SERVICE PROCEDURE

22525 / 22560
JANUARY, 2023

SUBJECT: SAFETY RECALL 22525 Variation 22560
Hex Flange Lock Nut on certain IC Bus® CE Series
and Electric CE Series vehicles built 03/01/2022
thru 08/17/2022.

Figure 1. Steer Axle Shackle

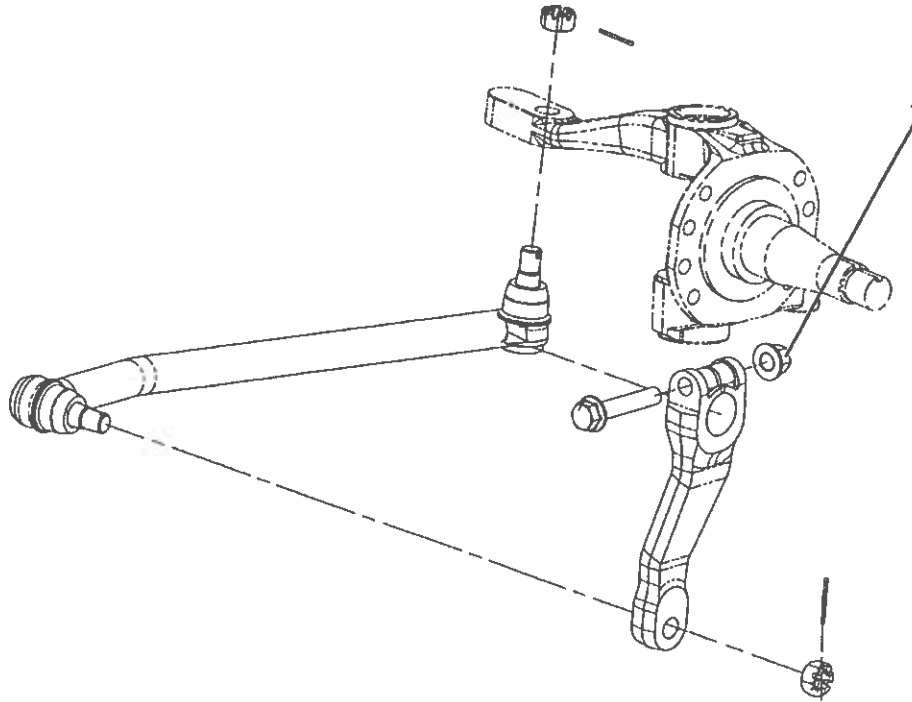
7. Access nuts (Figure 1, Item 1) securing the front steer axle shackle.

NOTE: After installation of each nut, ensure at least one thread is protruding past the top edge of the nut.

8. Remove and replace nuts (Figure 1, Item 1). Using a torque wrench, tighten nuts to 330 - 370 lb-ft (450 - 500 N·m).
